**REF120051 (Carmel Lagoon Ecosystem Protective Barrier, Scenic Road Protection  
Structure, and Interim Sandbar Management Plan Project)  
CEQA Comments regarding Draft EIR**

Review period of December 2, 2016 through January 31, 2017

**EXHIBIT A**

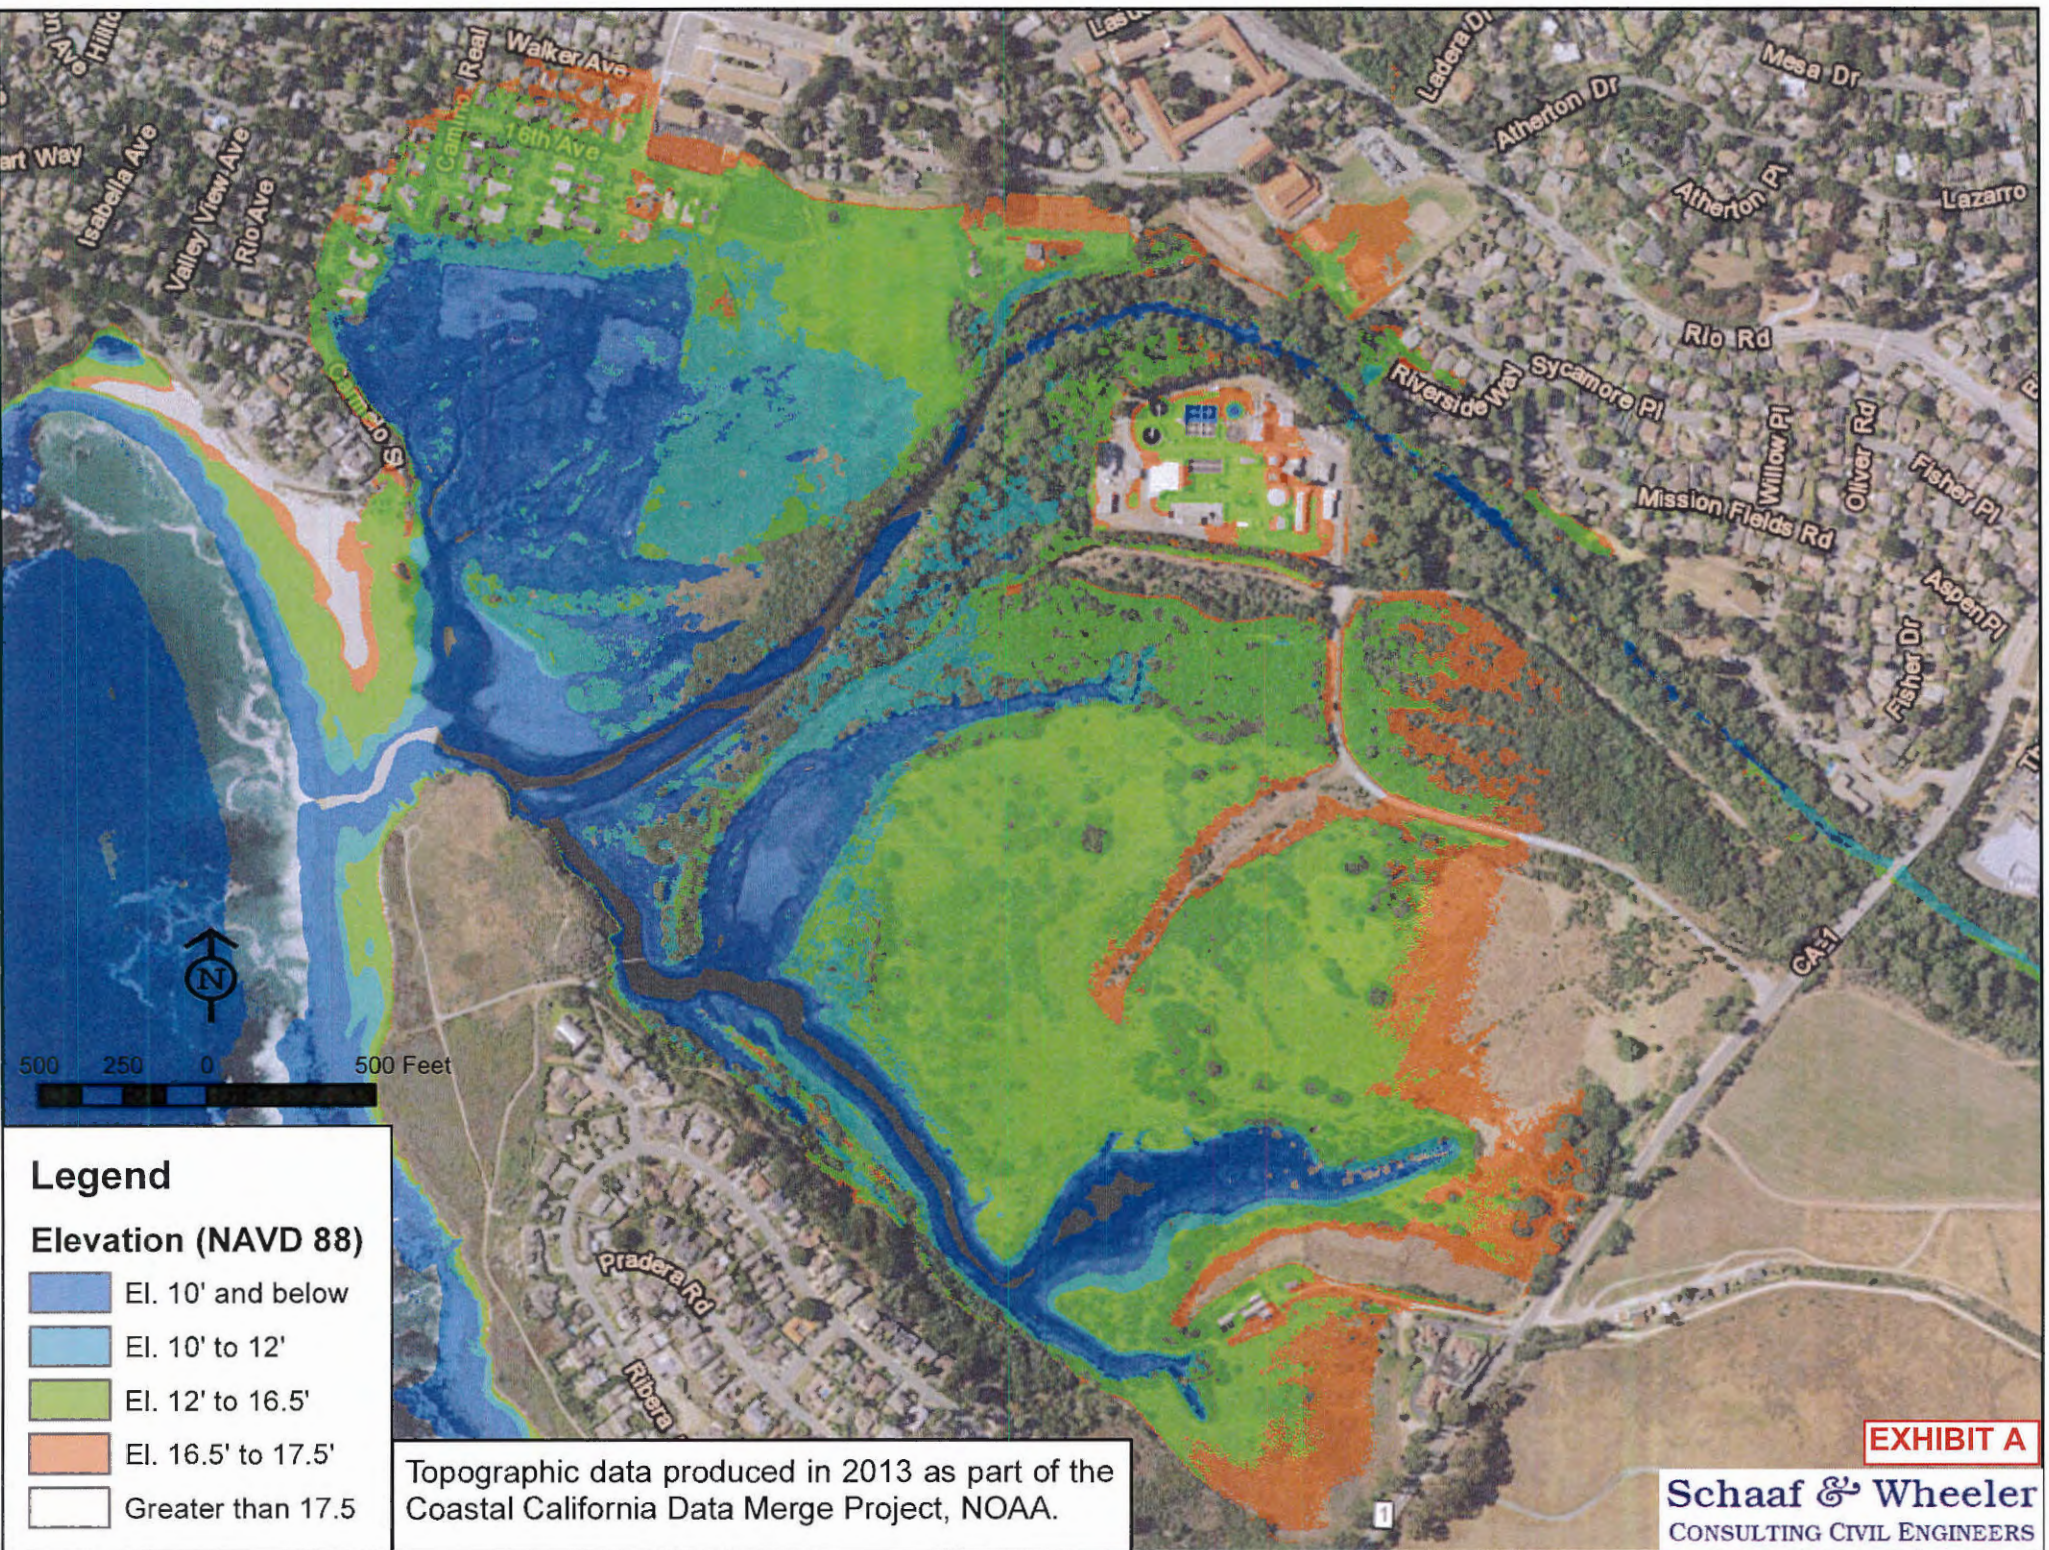
The DEIR claims that there is a 16ft elevation surrounding the CAWD treatment plant. That claim is misleading and should be corrected. The claim apparently is due to vegetative duff and grass clippings placed along the southern boundary of the plant grounds. The vegetative material easily saturates and then washes away. CAWD staff has requested that County staff visit the treatment plant to further observe this vegetation and get confirmation that this elevated area is pervious and would not serve as a deterrent for water.

The DEIR claim that "therefore such an increase in breaching elevation of 16 feet would not cause surface flooding at the CAWD Facility..." (page 4.8-43) is not correct and results in materially and significantly inaccurate conclusions. Contrary to the County claim, there is no doubt that an increase in water levels to 16 feet would cause surface flooding at the CAWD facility.

FIGURE 1  
5/15/2005

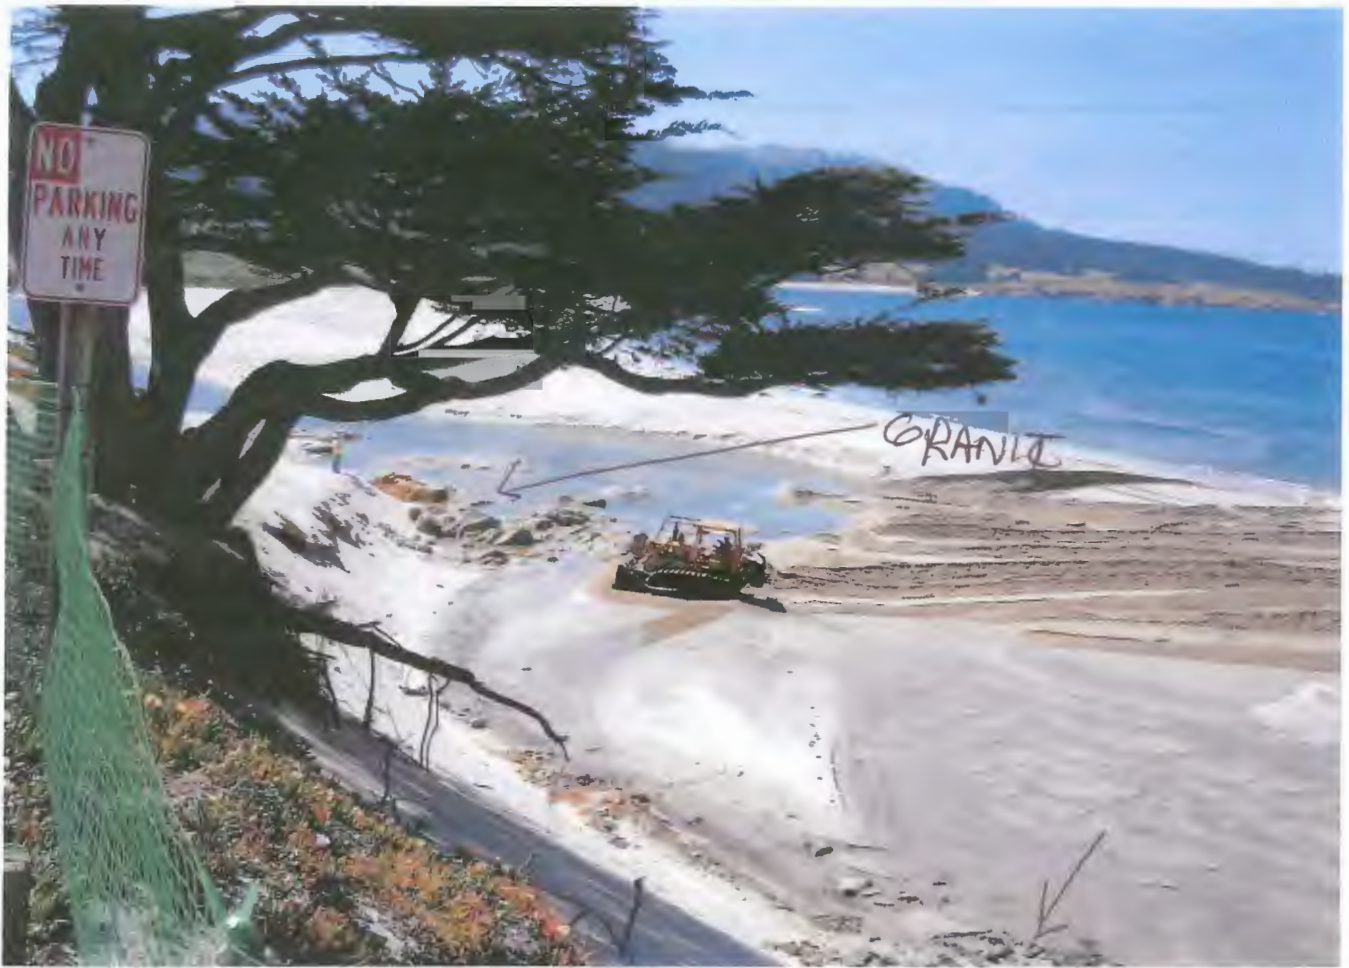
1. Between the parking lot and the heritage Cypress Tree there are granite outcroppings of irregular height, and possibly areas amongst them with no bedrock. (Figure 1 on 5/25/2005)

FIGURE  
2

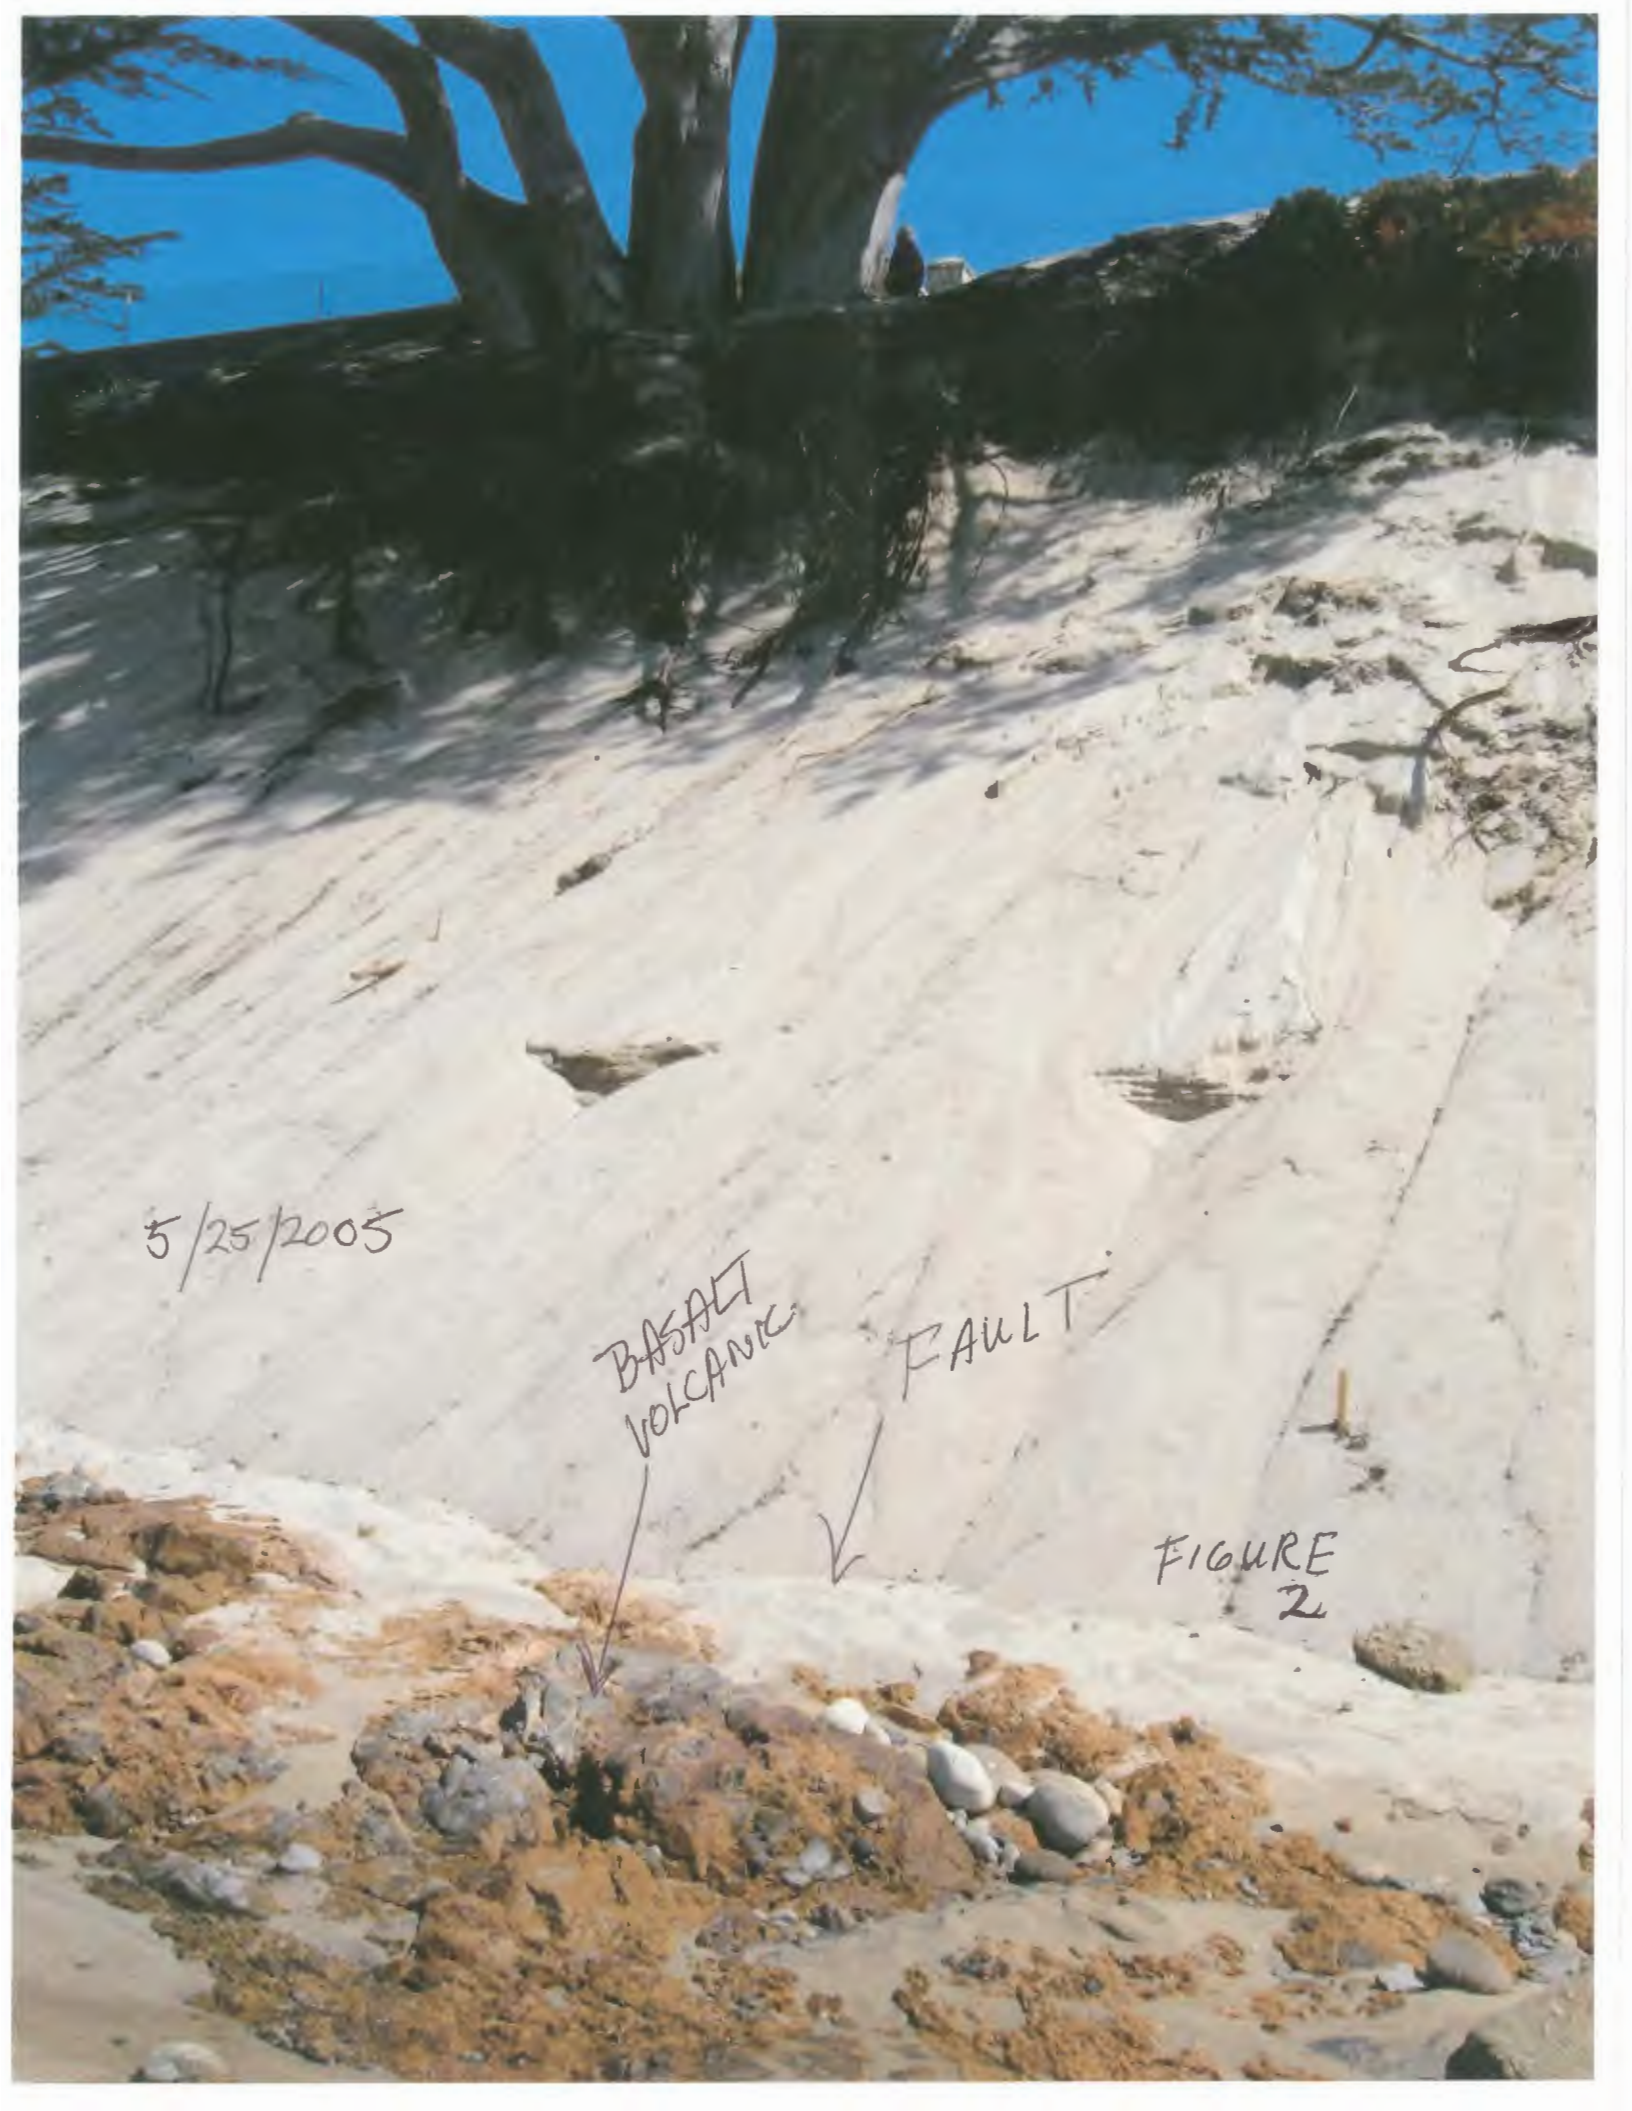
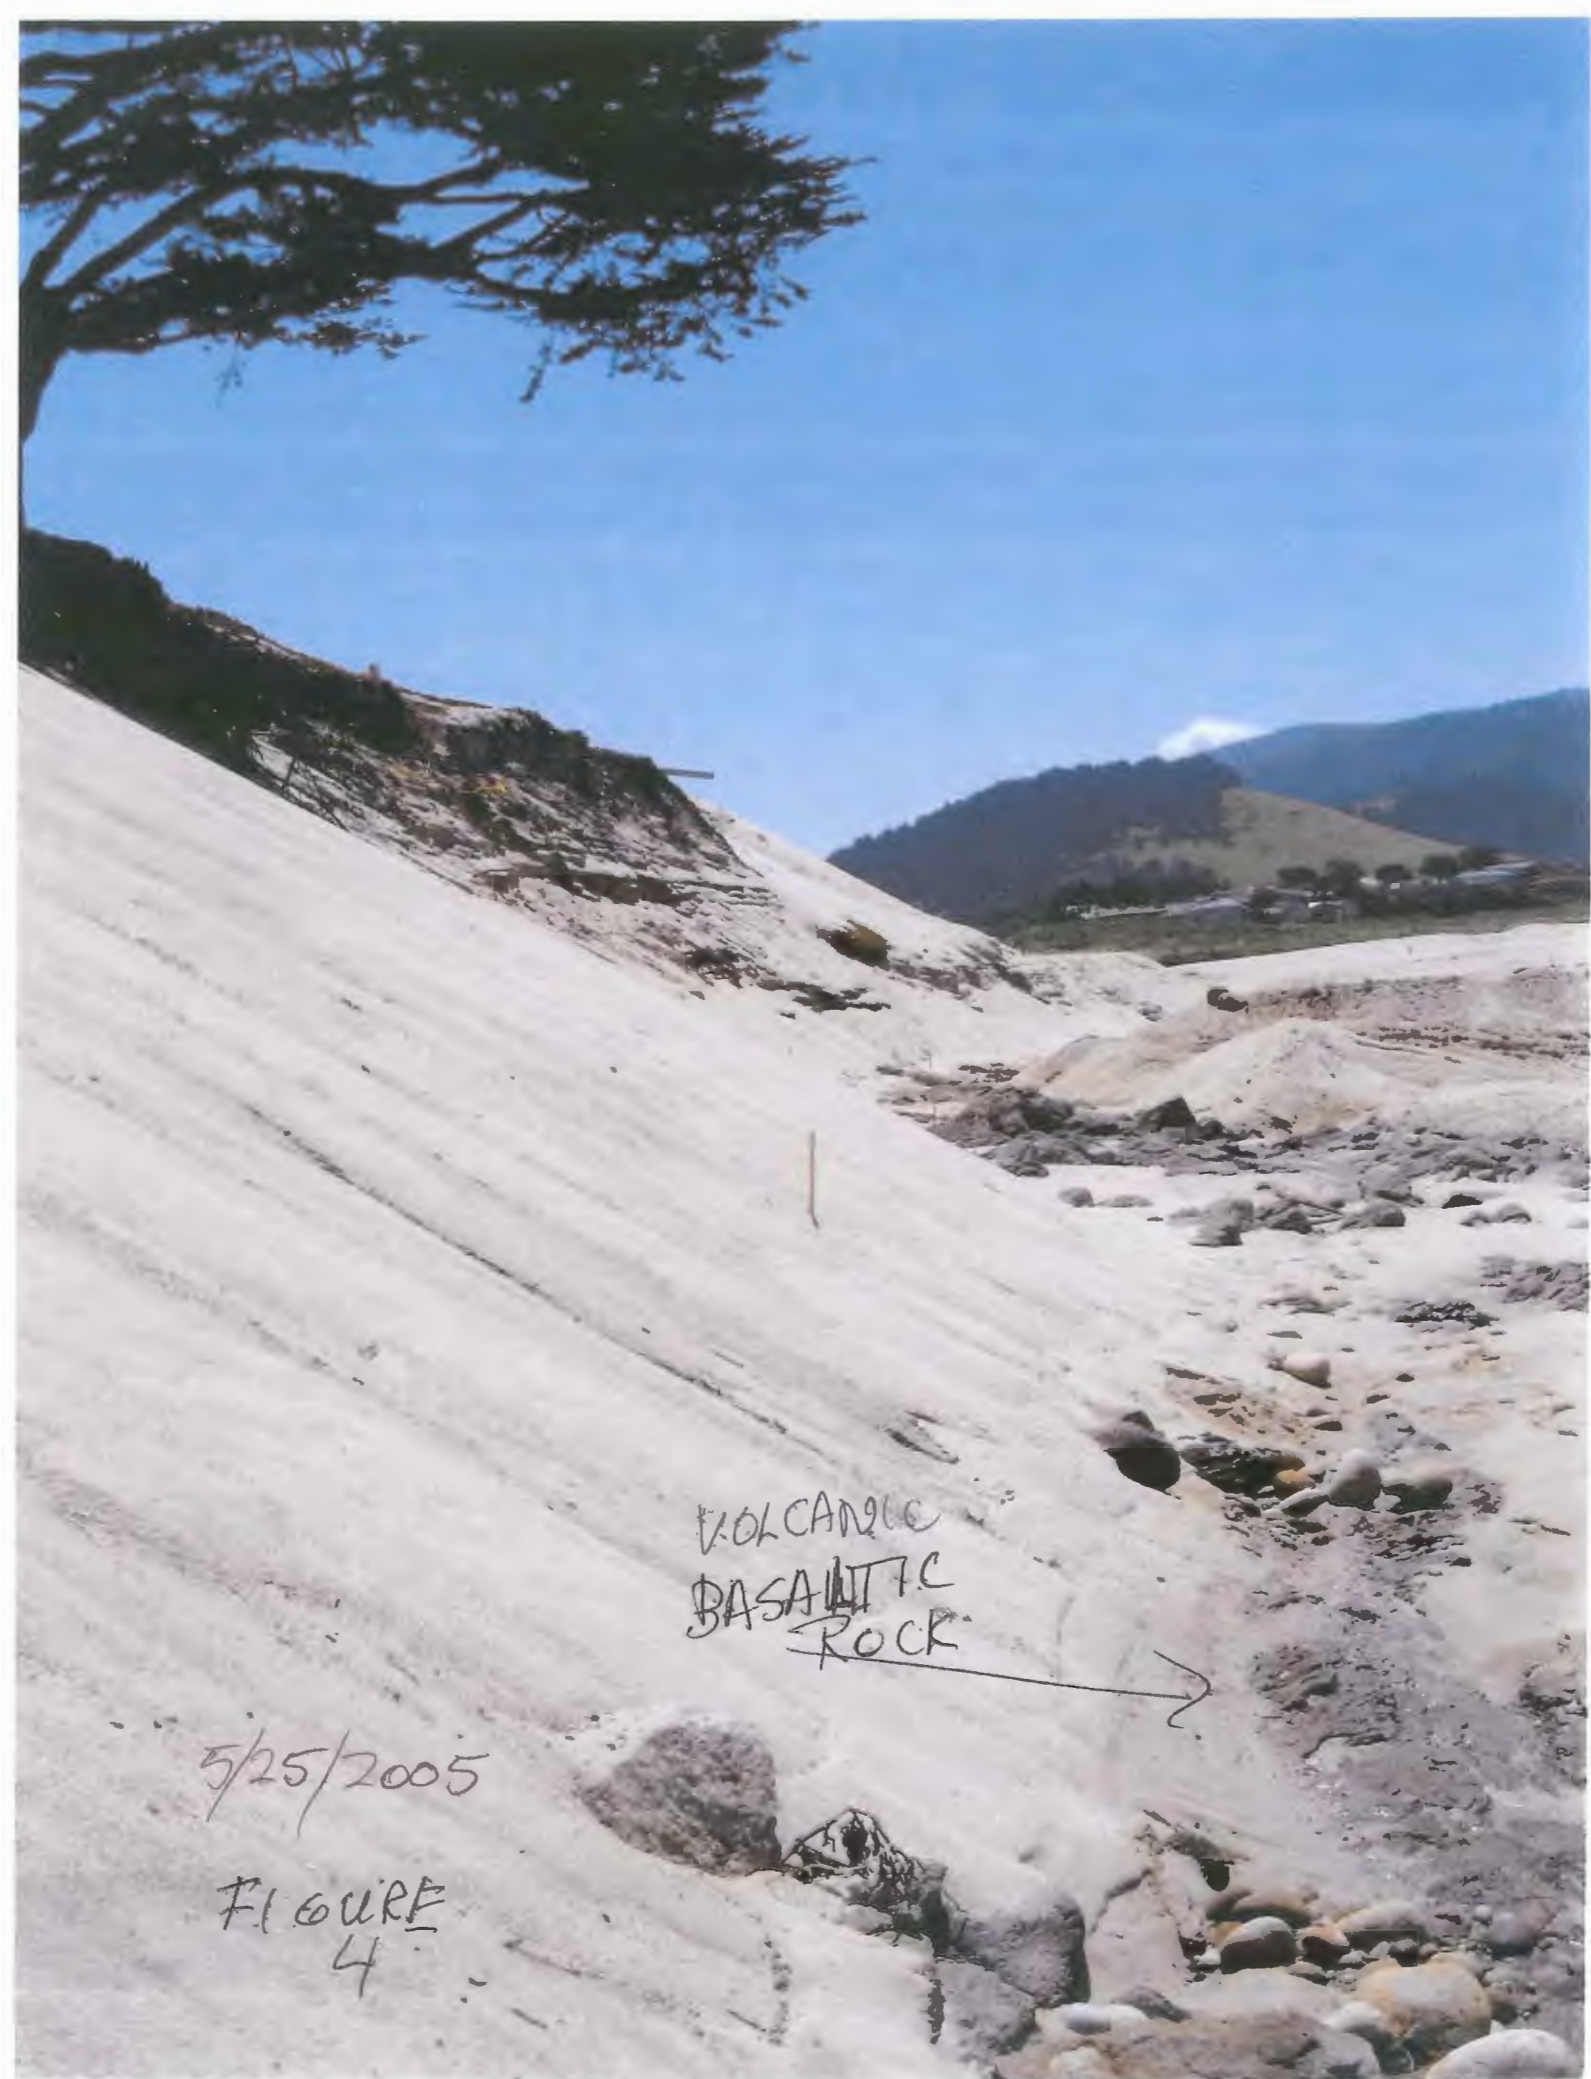
2. Then near the base of the bluff below the heritage Cypress there is a transition to a basaltic black rock mixed with orange rock that may constitute a fault according to Doug Smith CSUMB geology professor. (Figure 2-4 on 5/25/2005)
